Office Action Summary

09/484,421

DUBS ET AL.

FIG. 1

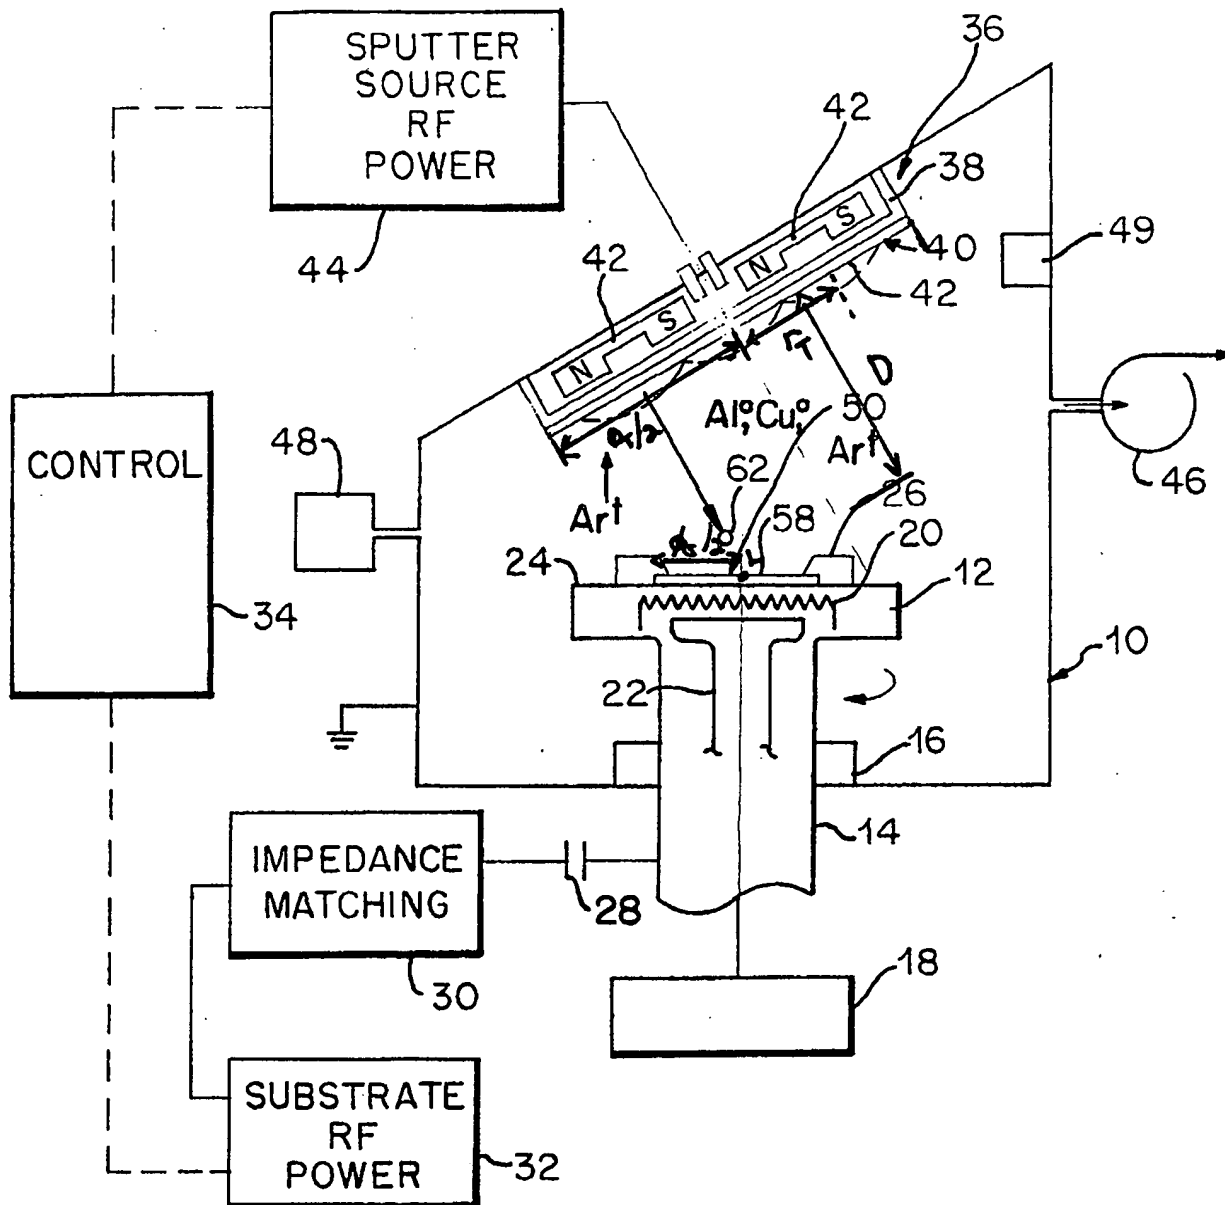
14. Claims 1, 3, 4, 6, 7, 9-12, and 15 are rejected under 35 U.S.C. 102(b) as being anticipated by U.S. patent No. 4,756,810 (Lamont).

Fig. 1 discloses a sputtering chamber comprising a magnetron sputter source 36 with new sputter surface 42 symmetrical about a central axis of the source. A substrate carrier 12 is arranged to be drivingly rotatable about a substrate carrier axis via rotation means 18. The central axis of the magnetron source and the substrate carrier central axes are oblique to one another (as applied to claim 1).

The axes which defines each of the target and substrate carrier are infinite along the plane which defines each of these axes. Since the axes are oblique, they will intersect (see attached marked up copy of Fig. 1 as applied to claim 3). The angle of the target surface relative to the substrate carrier is between 30 and 60° (Fig. 1 and col. 7, lines 49-51 as applied to claim 4). The substrate carrier is positioned horizontally relative to the bottom of the chamber (as applied to claim 6). The target surface is greater than the substrate to be coated (Fig. 1 as applied to claim 7).

Lamont has an inherent distance D (the smallest spacing between the central axis and the substrate carrier from the sputter surface) and the radius r_T (the largest erosion depth profile) which would be in the central region of the outer magnetic field lines (See Fig. 1). Given that Lamont inherently has these two features in the same configuration as the instant claims and that the approximated distance D as compared to the radius r_T is about twice as great, one of ordinary skill in the art would expect this configuration to result in an inherent ratio between $\frac{1}{4}$ and $\frac{2}{3}$ (as applied to claim 9). As well given the relative relationship of distance D in comparison to the diameter of the target, one of ordinary skill in the art would expect that the target diameter would be about twice as great as the smallest distance D (as shown in marked up copy of Fig. 1 as applied to claim 10). Distance D appears to be about the same length as that of the substrate diameter and would inherently arrive at a ratio of 1.8 or less (as applied to claim 11). The diameter of substrate receiving surface is about half the diameter of that of the target (as applied to claim 12).
